13 March 2018

Reference: Report Addendum to Comprehensive Soil Investigation and Septic System Design  
JPF Properties LLC Property; PIN 1537-17-7973

This addendum is for the report issued 27 December 2017 for the property located at 1560 George Perry Lee Road in Dunn, Harnett County, North Carolina. In that report, a detailed septic system design was provided for the proposed initial system and repair area for the business. Since that report was issued, it has come to our attention that there is a 30ft road easement straddling the western property line beside the proposed septic fields (see attached map).

Figure 2. Septic System Layout

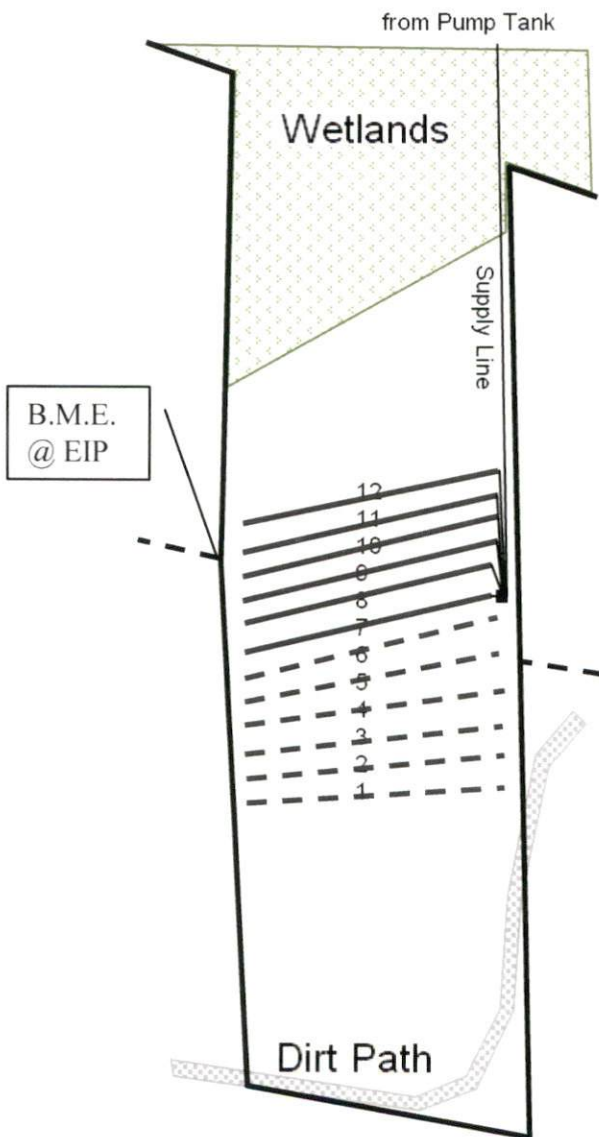
Due to the presence of the road easement, the available space for the septic drainfield is reduced slightly. The setback for septic drainlines from a property line is typically ten feet. However, the presence of the road easement effectively increases the setback along this property line to 15 feet because drainlines may not be installed in the easement.

An easy solution would be to reduce the length of each line of the system by five feet. The initial drainfield was designed as six conventional drainlines each 141 feet long. Reducing each line by five feet would result in six conventional drainlines each 136 feet. In this scenario, the long term application rate would back calculate to 0.42 gal/day/sqft. Soil observations made at the site support this loading rate.

Another solution would be to convert the system from conventional gravel drainlines to accepted status drainlines, such as EZflow. Use of accepted status drainlines in place of conventional lines allows the required amount of linear drainline to be reduced by up to 25%. Given a daily design flow of the facility of 1016 gallons and a loading rate of 0.4 gal/day/sqft, the minimum amount of accepted status drainline is calculated as 635 feet. This could be evenly distributed into six lines with each drainline 106 feet.

Another option would be to add an additional drainline to each system. Additional usable soil area is available above the proposed repair area which is not currently utilized in the design. Each system (initial and repair) is currently designed with six lines, but could be redesigned with seven conventional drainlines each 121 feet long.
